# City of Richmond

## Report to Development Permit Panel

**File:** DP 18-829204

**Re:** **Application by Fougere Architecture Inc. for a Development Permit at  
9391, 9393 and 9411 No. 2 Road**

UNIT 10B2-CONVERTIBLE UNIT

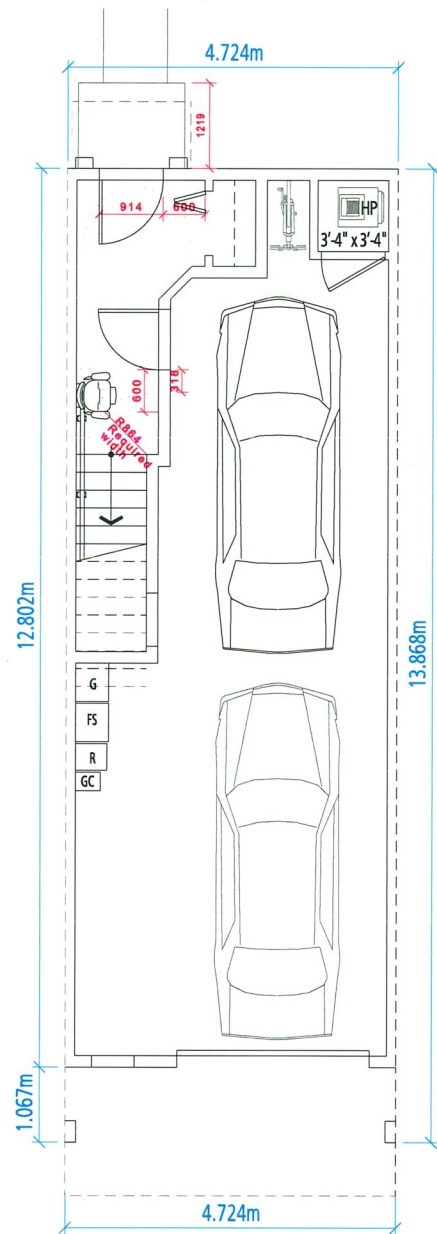
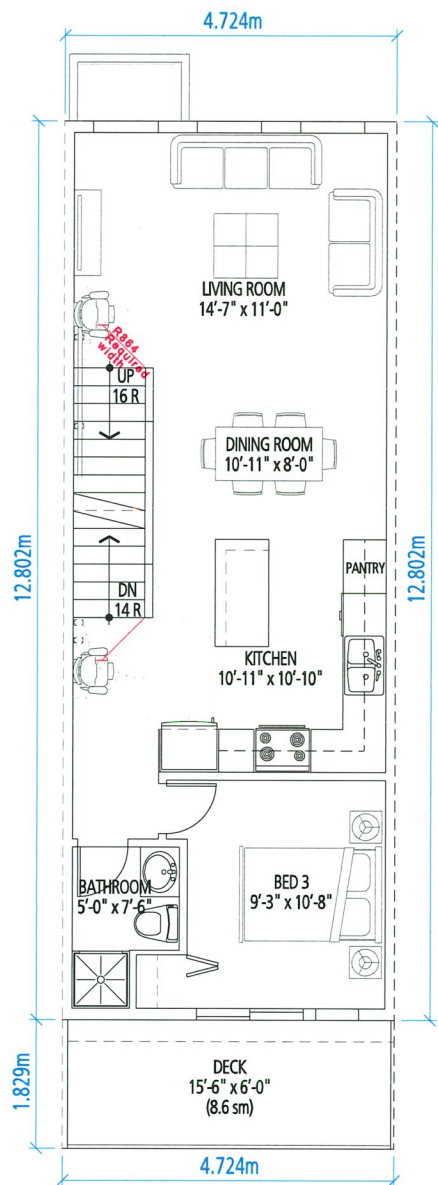
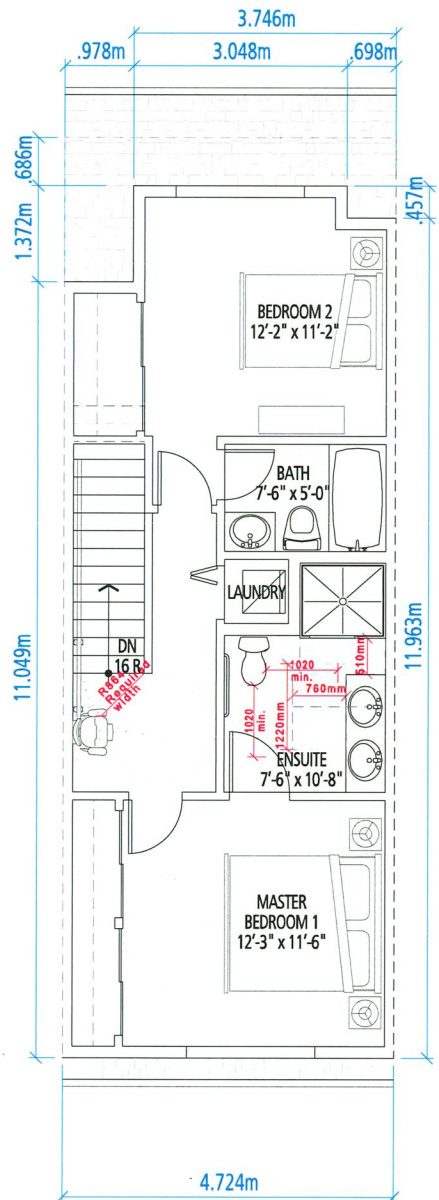
- appreciate the provision of a convertible unit in the proposed development; however, a resident in a wheelchair or using a walker cannot move up from the garage to the upper floors in a chairlift due to inadequate manoeuvring space in the entry; most importantly, separate mobility equipment is required on each floor; the applicant is encouraged to provide adequate space for future installation of a vertical lift in future developments;

*We provide enough space in the entry for a wheelchair turning space (with a diameter of 1.5m). We are aware of the limitations of chairlifts and have previously considered moving the convertible unit to one of the 2 storey units. However, these units don't have an accessible outdoor space, which is why they were ruled out as adequate convertible units.*

*The design follows the "Convertible Unit Guidelines for Townhouses".*

DP 18-829 204

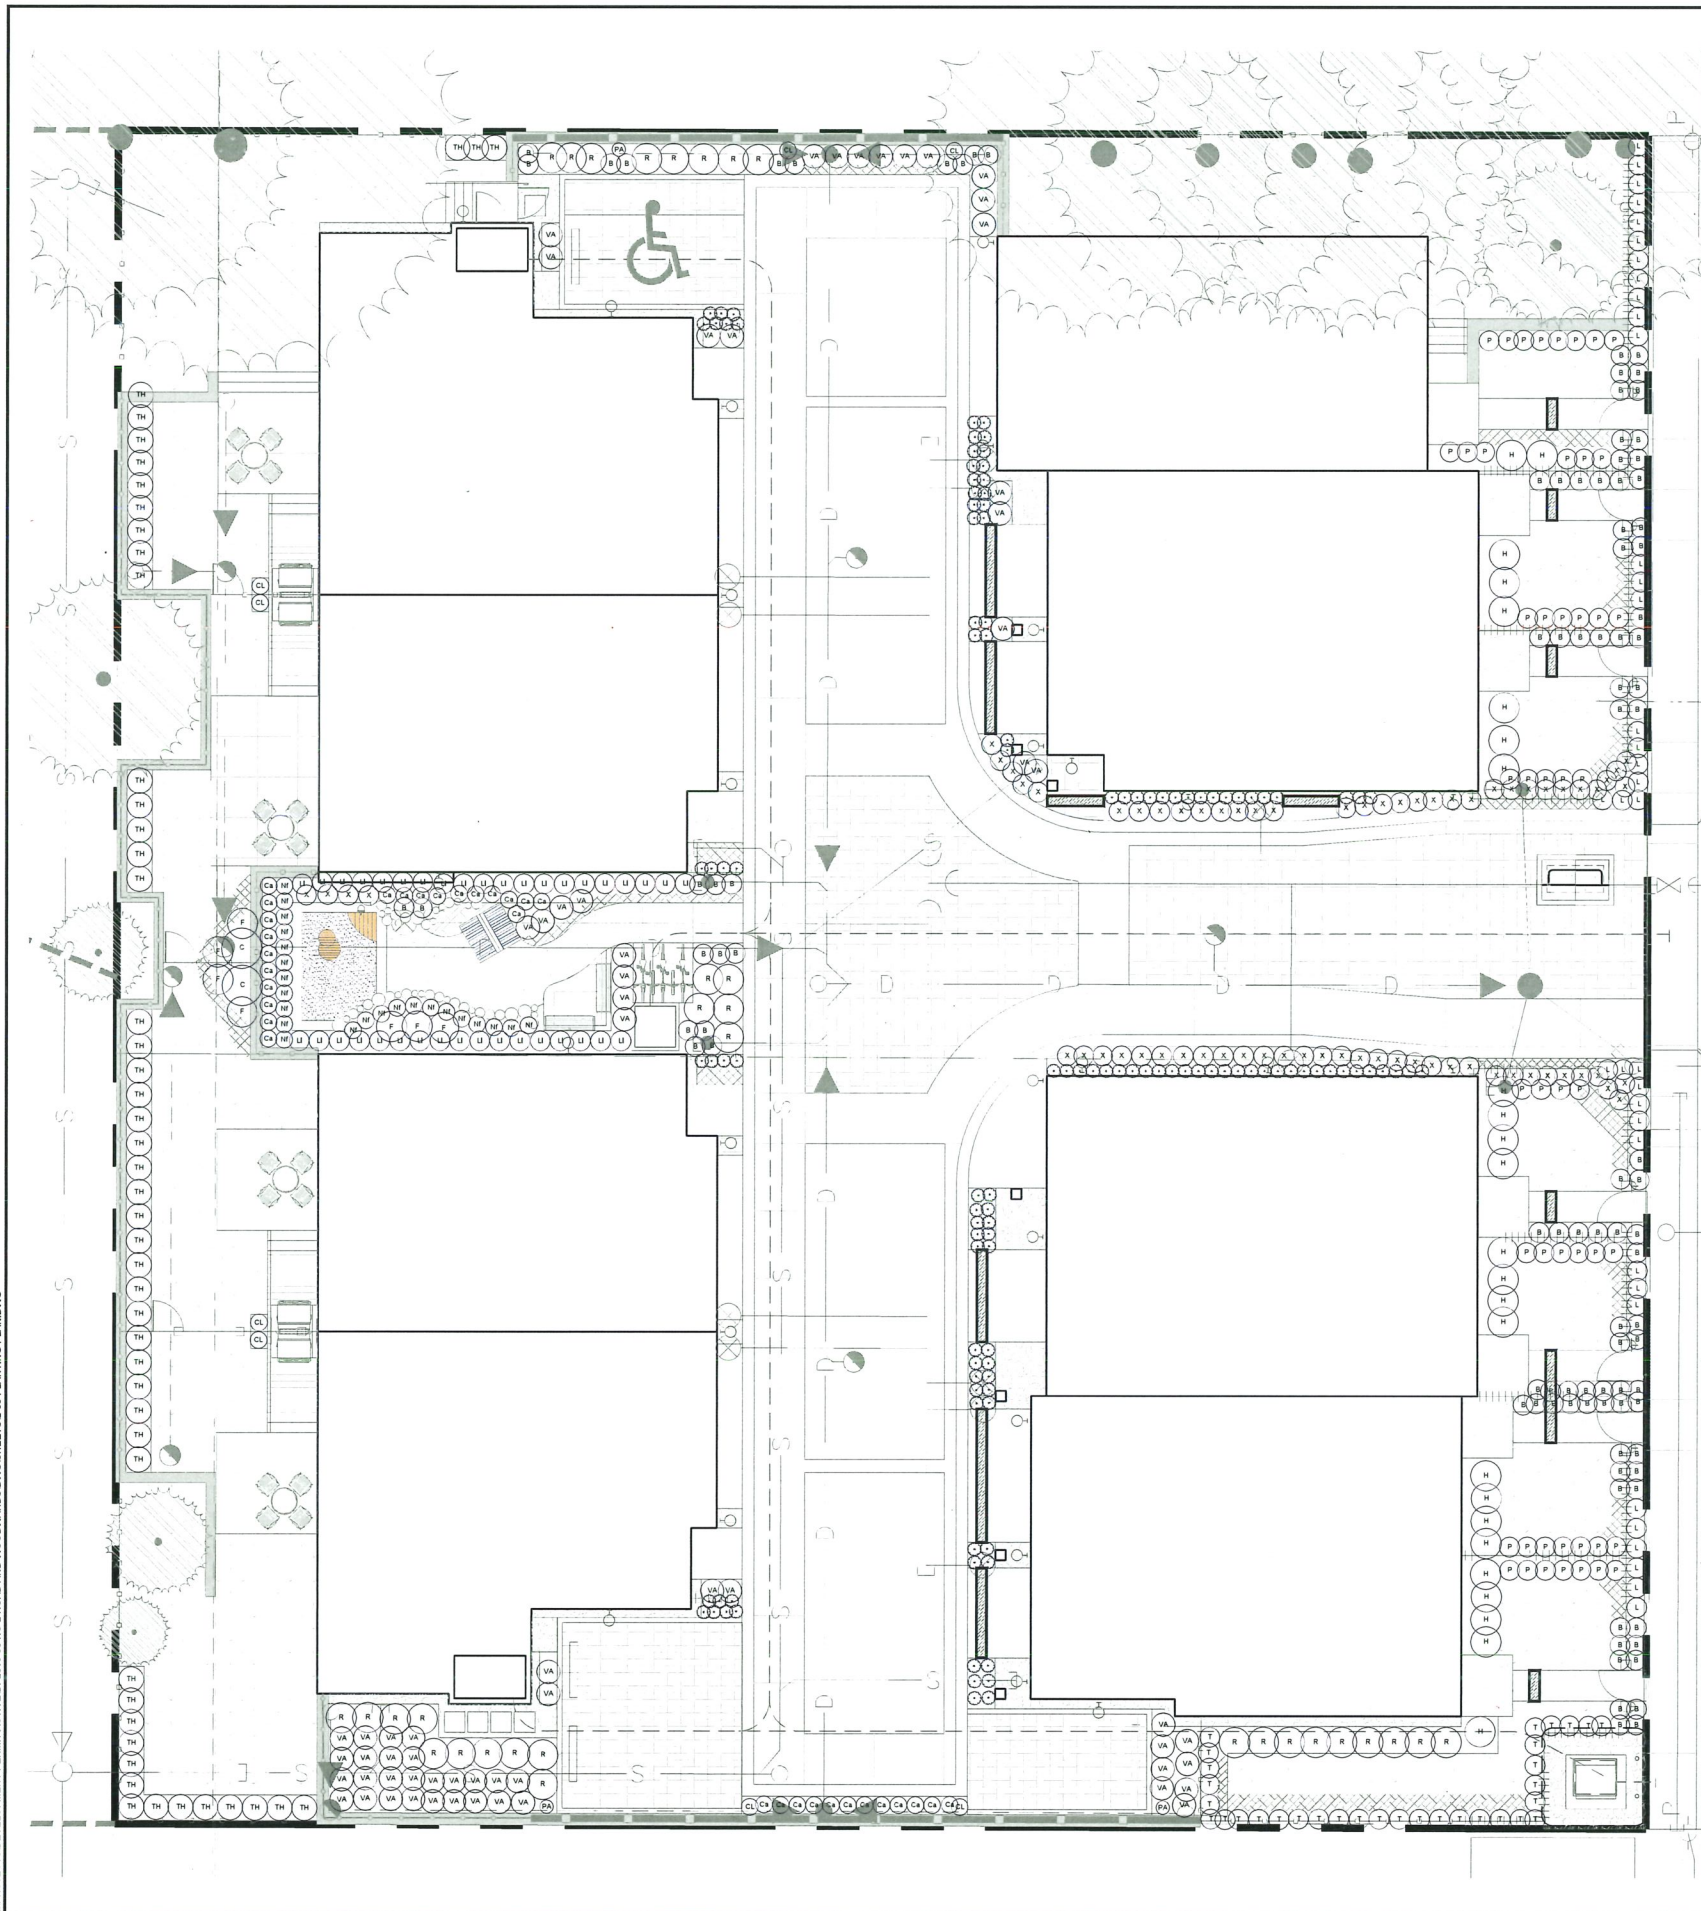
- concerned about the outdoor amenity area which could potentially become crowded into a dark space between two buildings and screened with dense planting along the west side; note that *Ceanothus* could grow to approximately 2.5 meters in height;

*The planting has been adjusted to remove cedar and ceanothus and provide smaller and brighter leafed plants, such as, feather reed grass, fire power heavenly bamboo, and lemon and lime privet. In addition, the privet is now providing the edge planting and can be maintained as a hedge in the size required by this space. These changes will brighten the space, and ensure it keeps an open feeling over the long-term.*

*The amenity has been expanded by 0.5 m to allow a larger planting zone before the fence. The stepped planting behind the sandbox including heavenly bamboo and blonde coloured feather reed grass behind, will provide a more open feeling and greater exposure to sun. The sand play items have been simplified to a table and hose bib to offer greater space within the sandbox and greater sun exposure.*
